# Access Compliance Report

## Public Rights-of-Way

### (Curb Ramps)

Intersection ID: N/A	Main Street: I-77_EXIT	Cross Street: W_T_HARRIS_BV	Location: NW
ADA ID: 448EC7E1A82B	Ramp Type: Para	Initial Pass/Fail: Fail	Overall Compliance: No
Severity Score: 12.5			
Codes/Mitigation Info/Possible Solution		Field Measurements/Component Compliance

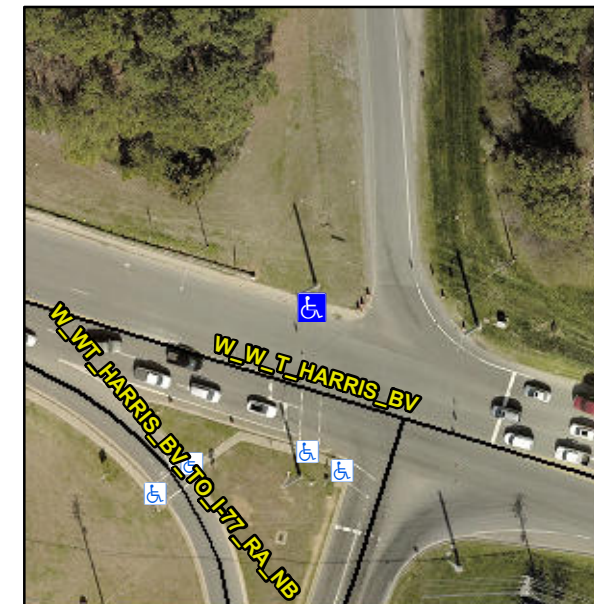
**DEBRIS COVERING RAMP**

**R304.3.2**

Compliance	Description	Data	Compliance	Description	Data
N/A	Ramp Length LT (in)	71.0	N/A	Ramp Length RT (in)	69.0
Yes	Ramp Width LT (in)	48.0	Yes	Ramp Width RT (in)	48.0
No	Ramp Slope LT (%)	11.7	No	Ramp Slope RT (%)	8.5
Yes	Ramp XSlope LT (%)	0.1	Yes	Ramp XSlope RT (%)	0.9
N/A	Landing Length (in)	N/A	N/A	DWS Provided?	N/A
N/A	Landing Width (in)	N/A	N/A	DWS Contrast?	N/A
N/A	Landing Slope (%)	N/A	N/A	DWS Length (in)	N/A
N/A	Landing X Slope (%)	N/A	N/A	DWS Full Width?	N/A
N/A	Landing Curb? (Y/N)	N/A	N/A	DWS Offset (in)	N/A
N/A	Shared Landing?	N/A			
N/A	Gutter Ponding?	N/A	N/A	Gutter Slope (%)	N/A
N/A	Gutter Lip Ht (in)	N/A	N/A	Gutter X Slope (%)	N/A
N/A	Painted X Walk1?	Yes	N/A	Painted X Walk2?	N/A
	X Walk 1 Direction	To S		X Walk 2 Direction	N/A
N/A	X Walk 1 Width (in)	111.0	N/A	X Walk 2 Width (in)	N/A
	X Walk 1 Slope (%)	0.7		X Walk 2 Slope (%)	N/A
	X Walk 1 X Slope (%)	1.4		X Walk 2 X Slope (%)	N/A
N/A	Ramp inside XWalk1?	Yes	N/A	Ramp inside XWalk2?	N/A

**Remove & Replace Entire Ramp.**
